DRAFT TECHNICAL MEMORANDUM

Subject: Lake Prevatt Minimum Flows and Levels Peer Review
Task B2: Draft Peer-Review Memorandum

Executive Summary

Figure 2. Lake Prevatt sub-watersheds (green polygons) delineated by Sarker and others (2023), over the ESRI World Street Map at a local scale.

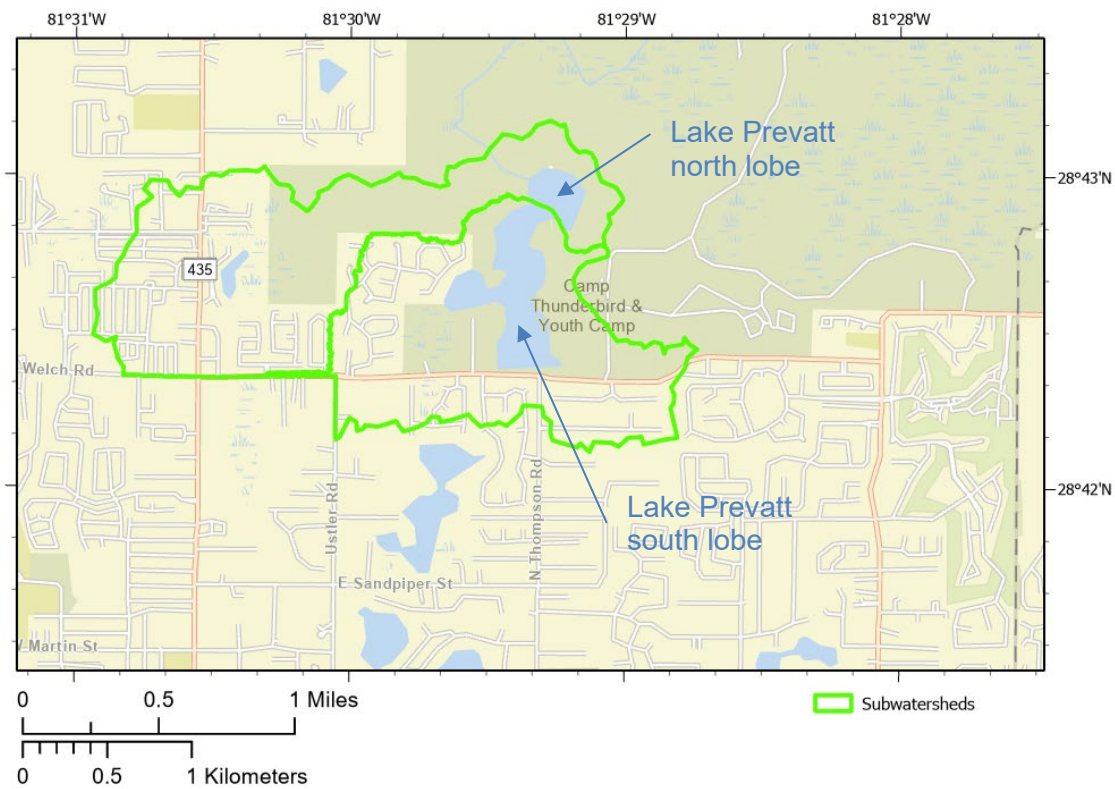
SJRWMD did not simulated flows from Lake Coroni to Lake Prevatt (**Figure 2**). SJRWMD also did not simulate flows from Lake McCoy to Lake Coroni (**Figure 2**).

SJWMD may wish to re-delineate the watershed that drains to Lake Prevatt to include areas that drain to Lake McCoy (**Figure 5**) and Lake Coroni (**Figure 6**). This re-delineation will conform to observations made by Manager Brooks, that water from Lake Coroni periodically flows to Lake Prevatt. SJRWMD may wish to inform this re-delineation with Professional Engineering Consultants (1997a) and select environmental resource permits (**Table 1**).

Figure 4. Professional Engineering Consultants, Inc., node-reach diagram for a simulation of surface-water flows and elevations in areas that drain to Lake Prevatt, Lake Coroni, and Lake McCoy; and inter-flow paths between these lakes.

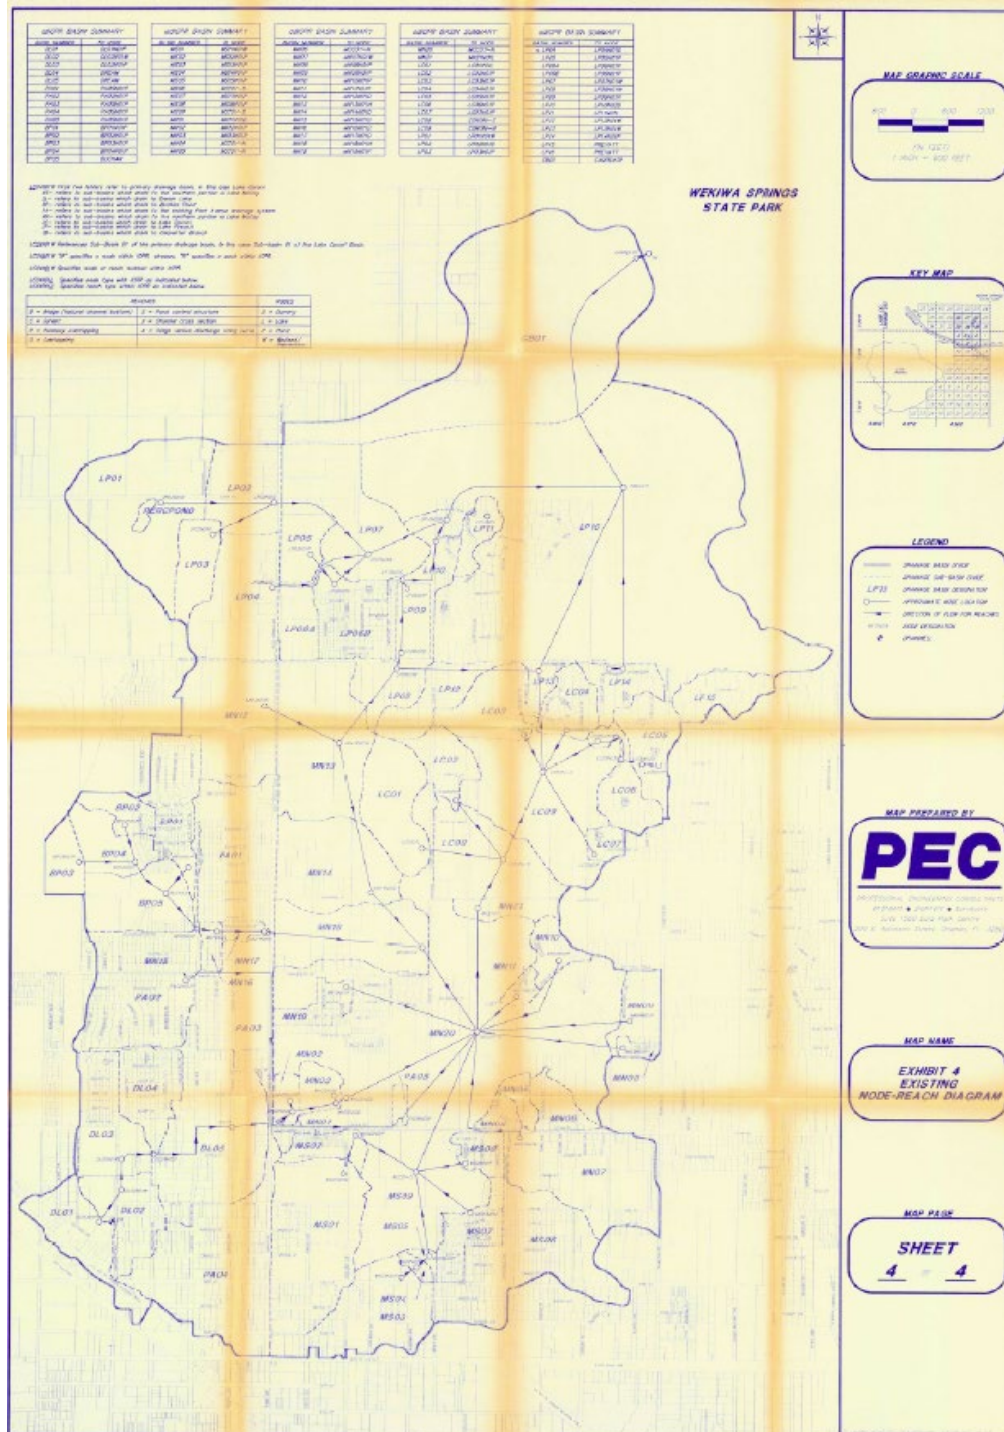
3. In March 1997, Professional Engineering Consultants, Inc., published a stormwater management plan of the surface-water conveyance system that drains to Lake McCoy, Lake Coroni, and Lake Prevatt (**Figure 4**). Professional Engineering Consultants conducted the study for Orange County, the City of Apopka, and SJRWMD. Professional Engineering Consultants field verified the watershed boundary, measured geometry and elevation of stormwater infrastructure, and measured or estimated geometry and volume of stormwater retention and detention facilities. Professional Engineering Consultants simulated water-surface elevations at selected locations in the watershed, such as in lakes and stormwater retention facilities; and flow rates in selected surface-water conveyance features, such as culverts, channels. Professional Engineering Consultants simulated flows between Lake McCoy, Lake Coroni, and Lake Prevatt. Geosyntec Consultants attach Professional Engineering Consultants (1997a) to this technical memorandum.

During the task A watershed visit on December 11, Wekiva Springs State Park Manager Robert Brooks asserted discharge from Lake Coroni inundates the pond near the park manager's residence [fig. 6 and photo. 15 of King (2023)], one-to-three days after relatively large episodic rainfall events, such as rainfall events associated with 2010s and 2020s era hurricanes and tropical depressions. During

these events water in Lake Coroni flows north, into the pond, and subsequently into Lake Prevatt. Manager Brooks stated that the maximum pond stage in response to this episodic discharge inundates the pond adjacent to the park manger's residence [photo. 15 of King (2023)] to a point that is equidistant between the normal pond shoreline and the park manager's residence. Manager Brooks witnessed these flows and stages.

Figure 5. Lake McCoy watershed (orange polygon) and sub-watersheds simulated by Sarker and others (2023) (green polygons). Lake McCoy watershed boundary delineation is very approximate, and loosely based on Professional Engineering Consultants (1997a).

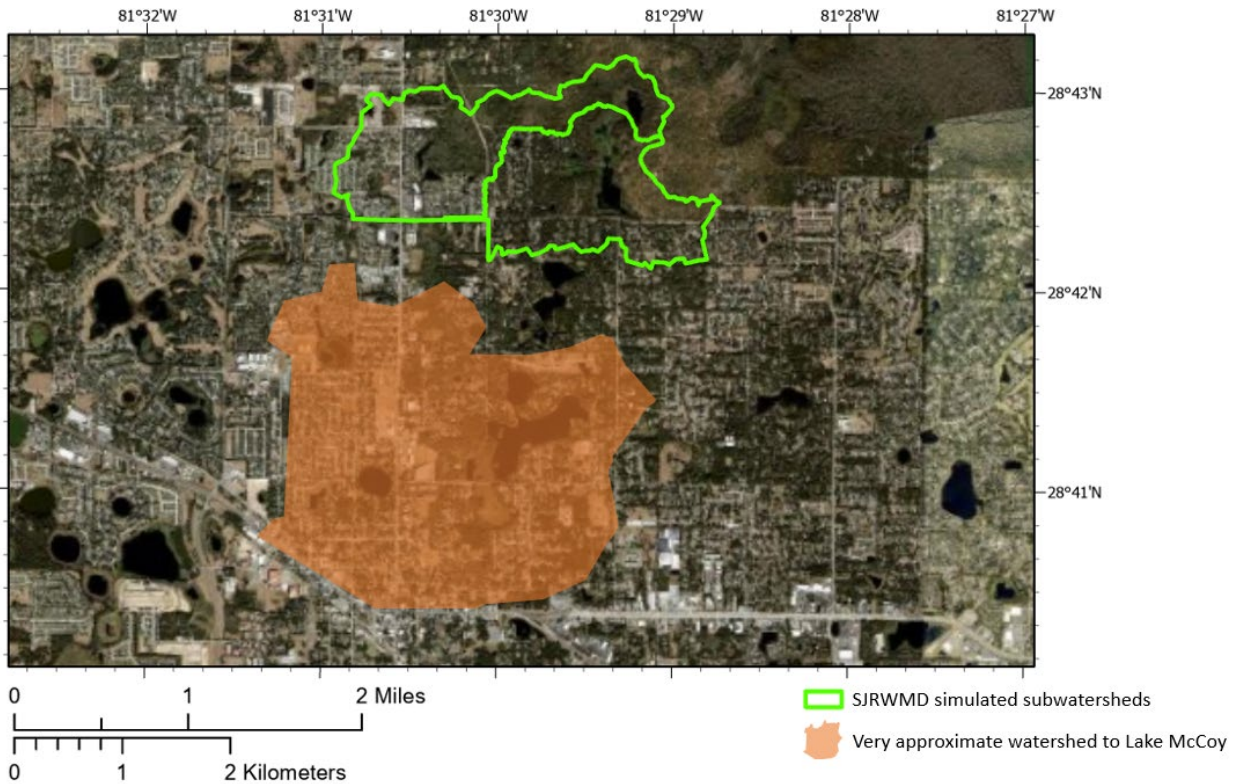
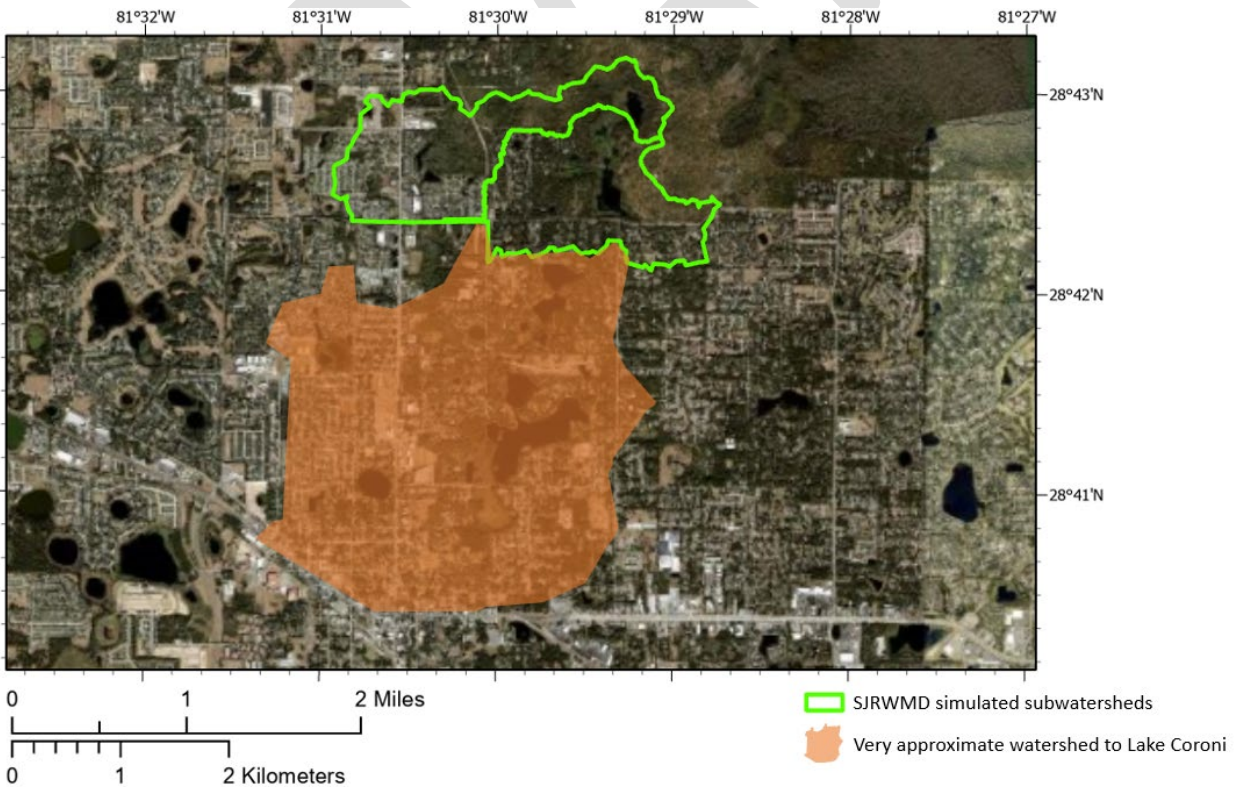
11. Sarker and others (2023) did not delineate areas that drain to Lake Coroni or Lake McCoy as periodically draining to Lake Prevatt, during, for example, rare, episodic events with annual exceedance probabilities greater than, say, 30 percent. Professional Engineering Consultants (1997a) delineated (Figure 10) areas that drain to Lake Coroni and Lake McCoy as draining to Lake Prevatt (Figure 4).

SJRWMD may wish to delineate areas that drain to Lake Coroni and Lake McCoy as draining to Lake Prevatt. SJRWMD may wish to revise the simulation described in Sarker and others (2023) to include Lake McCoy and Lake Coroni watersheds, and include surface-water conveyance infrastructure, stormwater detention infrastructure, stormwater retention infrastructure in areas that drain to Lake McCoy and Lake Coroni.

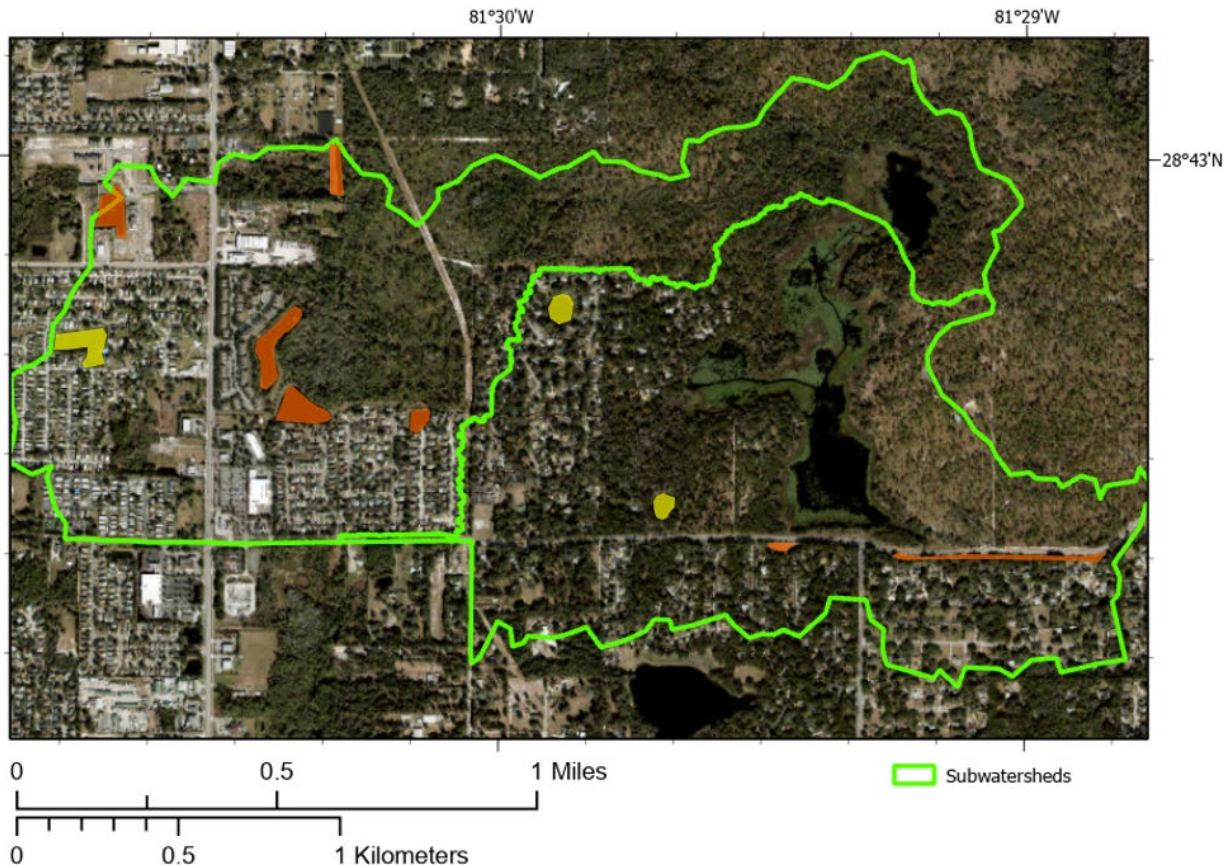
4. Stormwater management systems exist in the Lake Prevatt watershed, which detain or retain stormwater (**Figure 7**). Natural ponds also exist in the Lake Prevatt watershed. These ponds likely retain or detain surface-water flows from the watershed to Lake Prevatt. SJRWMD may wish to revise the simulation to include constructed stormwater management systems and natural ponds, to quantify detention or retention of surface-water flow to Lake Prevatt.

9. SJRWMD may wish to revise the simulation described in Sarker and others (2023) to include surface-water conveyance infrastructure, stormwater detention infrastructure, stormwater retention infrastructure in areas that drain to Lake Prevatt (comment 4, **Figure 7**).

SJRWMD may wish to revise the simulation described in Sarker and others (2023) to include surface-water conveyance infrastructure, stormwater detention infrastructure, stormwater retention infrastructure in areas that drain to Lake Prevatt, some surface water may be detained, or retained in the upper watershed, south of Welch Road East, in the pond in front of Manager Brooks' residence, in a natural pond near Cedar Glen Drive, in stormwater management facilities north of Boulder Creek Court and east of Sunset Palm Drive, in a wetland north of Boulder Creek Court and east of Sunset Palm Drive, in a natural pond west of West Dottie Street, in a stormwater management facility west of Emerald Springs Drive, in wetland west of Tanglewood Lane, and in a wetland west of Jolly Avenue (**Figure 7**).

40. Sarker and others (2023, page 20) characterized the model simulation of Lake Prevatt north lobe stage as adequate (“the model adequately simulated”). Given the importance of lake levels with relatively greater exceedance probabilities to developing a minimum lake level, SJRWMD may wish to revisit whether simulated water-surface elevations being uniformly less than measured water surface elevations in a validation simulation by as much as six inches over exceedance probabilities from about 90 percent to almost 99 percent is adequate. SJRWMD may wish to consider the influence of storage in the upper watershed on lake levels with relatively greater exceedance probabilities (comment 4; **Figure 7**).

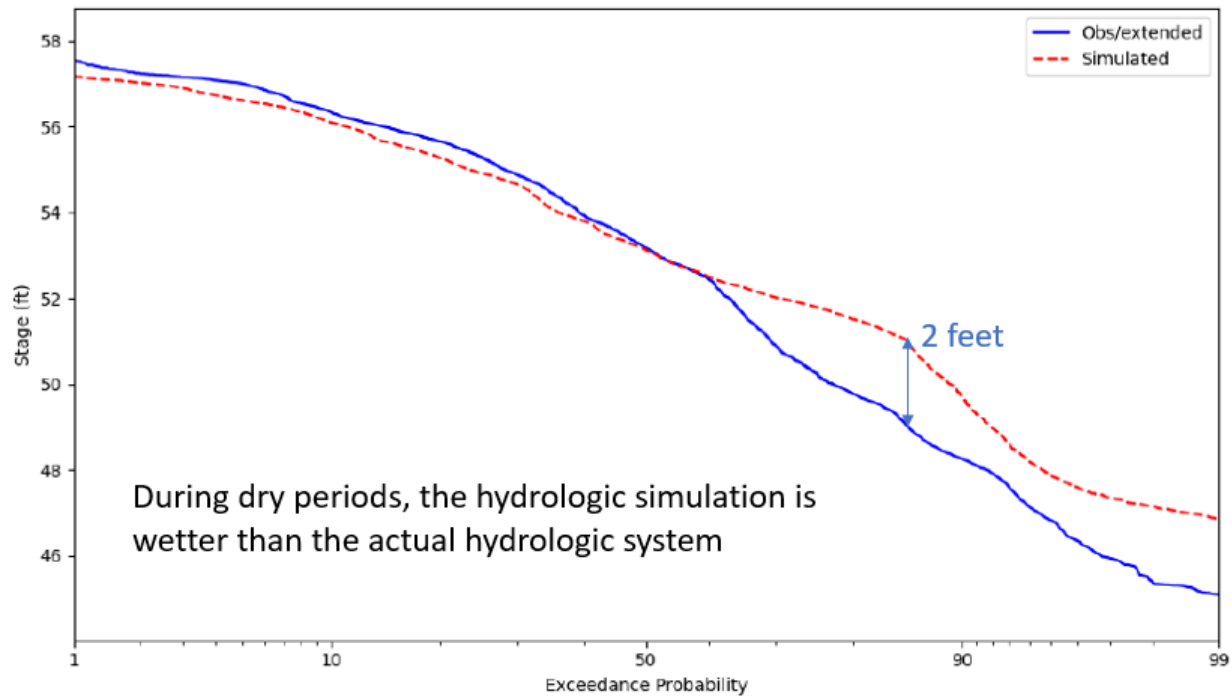
Sarker and others (2023) quantified measured and simulated, Lake Prevatt south lobe water-surface elevation exceedance probability (**Figure 8**). For example, Sarker and others (2023) show that a measured 48-foot water-surface elevation above NAVD88 has a 90-percent chance of being exceeded from 2008 to 2021. Sarker and others (2023) show that the simulated water surface elevation is as much as two feet greater than the measured water surface elevation, at the relatively lower-elevation, dryer side of the elevation-probability relationship. Restated: the simulation is wetter than measurements, during relatively lower stages, less than about 52 feet above NAVD88. Consequently, a tool that is wetter than the actual lake level, at the same exceedance probability, will inform a specified, regulatory, minimum lake level.

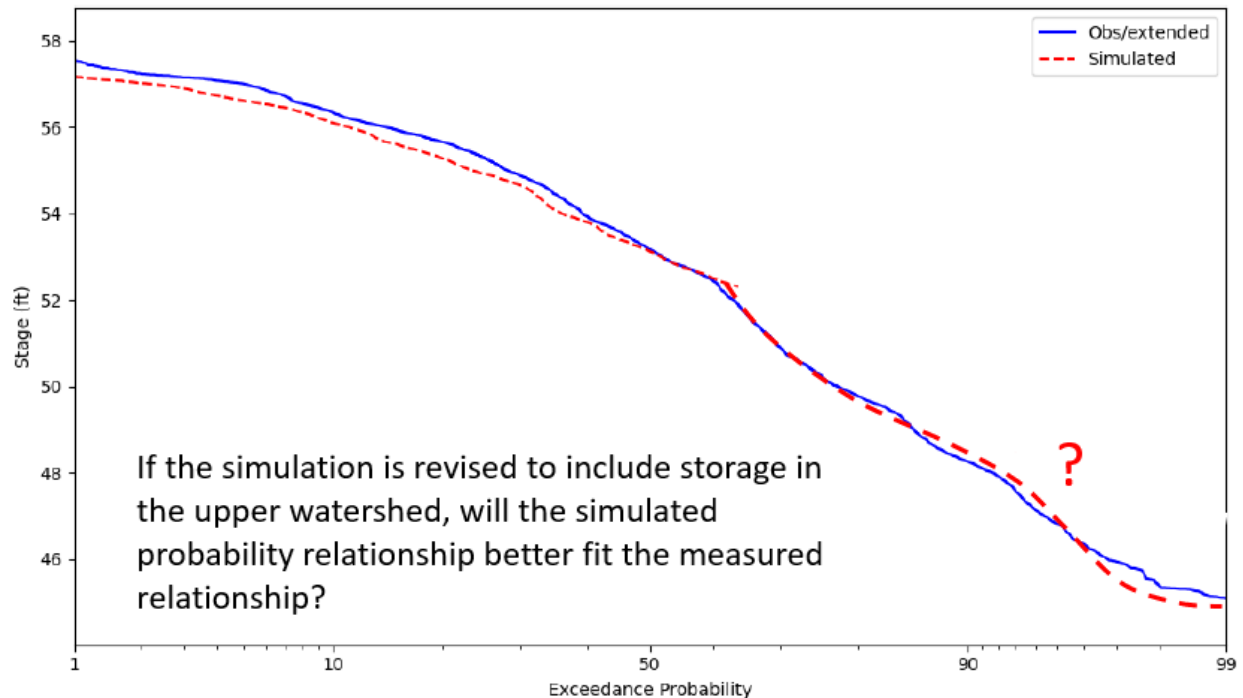
If SJRWMD make this revision the simulated exceedance probability relationship may fit better, the measured exceedance probability relationship (**Figure 9**).

Figure 10. Professional Engineering Consultants, Inc., node-reach diagram for a simulation of surface-water flows and elevations an area near Welch Road East.

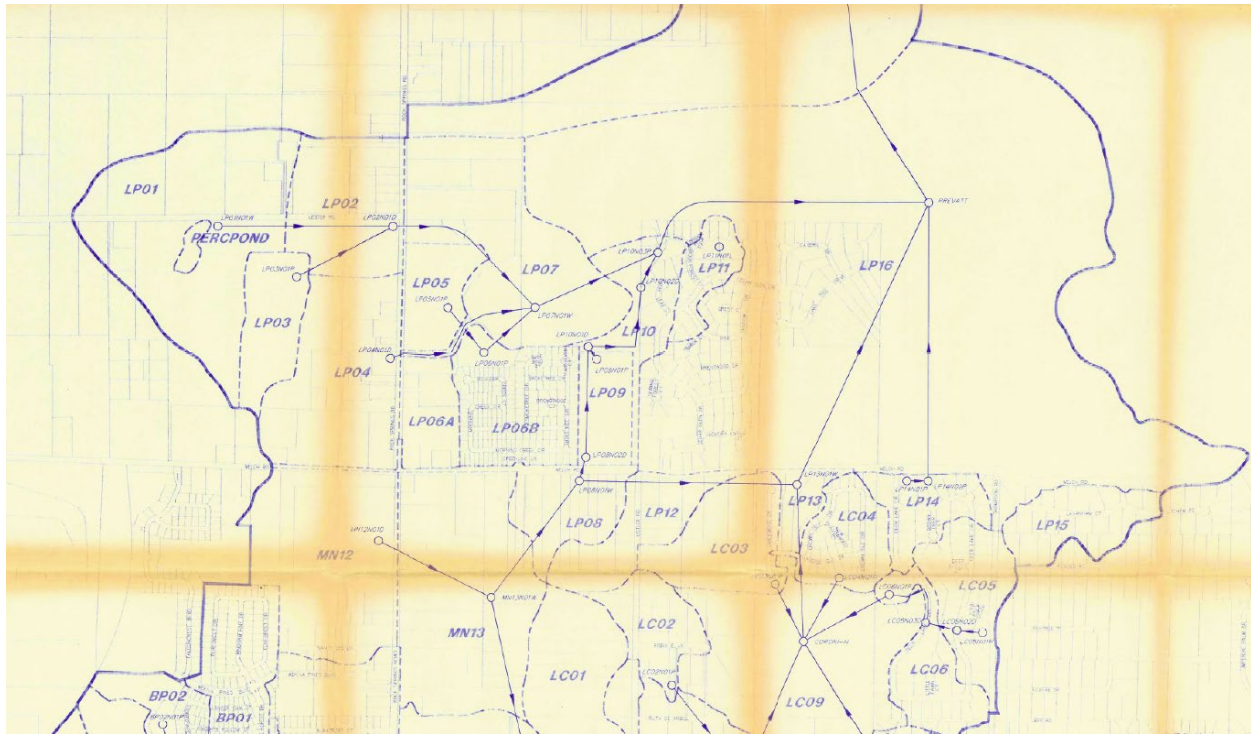
10. Sarker and others (2023) did not delineate wetland west of Tanglewood Lane, a wetland west of Jolly Avenue, and a wetland south of Welch Road East between Rock Springs Road and Ustler Road as draining to Lake Prevatt. Professional Engineering Consultants (1997a) delineated (**Figure 10**) wetland west of Tanglewood Lane (basin LP01), a wetland west of Jolly Avenue (basin LP01), and a wetland south of Welch Road East between Rock Springs Road and Ustler Road (basins MN13, LP08, and LP12) as draining to Lake Prevatt. SJRWMD may wish to re-delineate and refine sub-watersheds to include these areas as draining to Lake Prevatt, and revise the simulation described in Sarker and others (2023) accordingly.

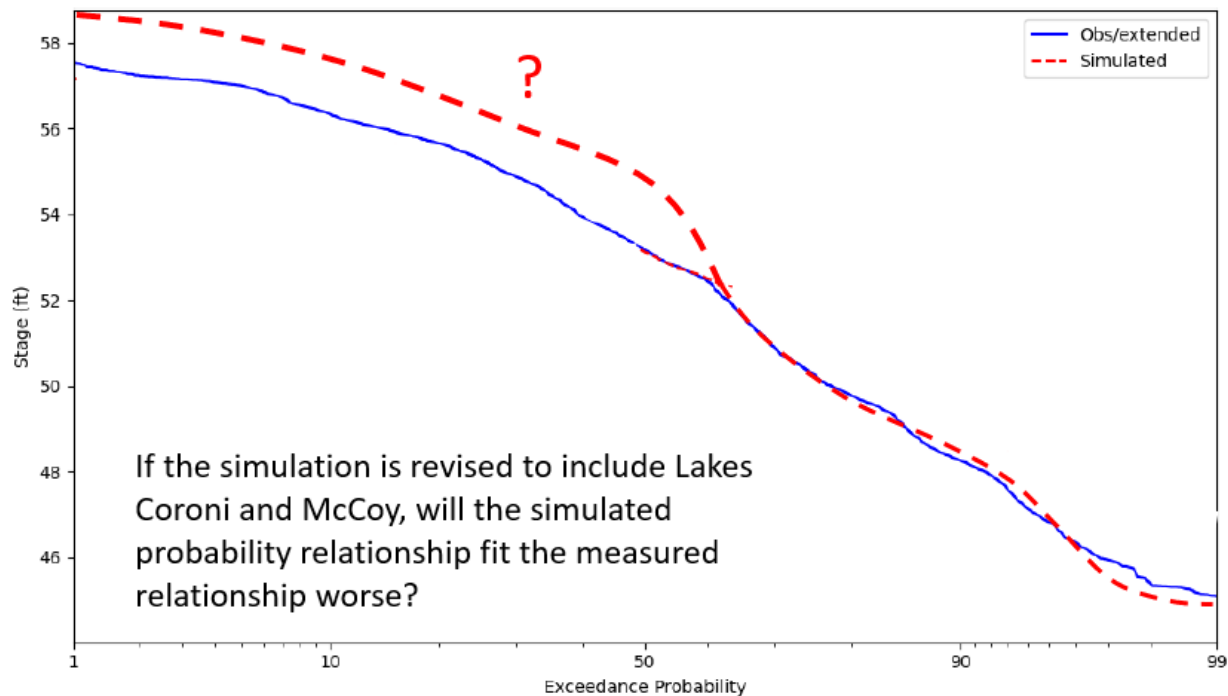
If SJRWMD make this revision the simulated exceedance probability relationship may change (Figure 11).
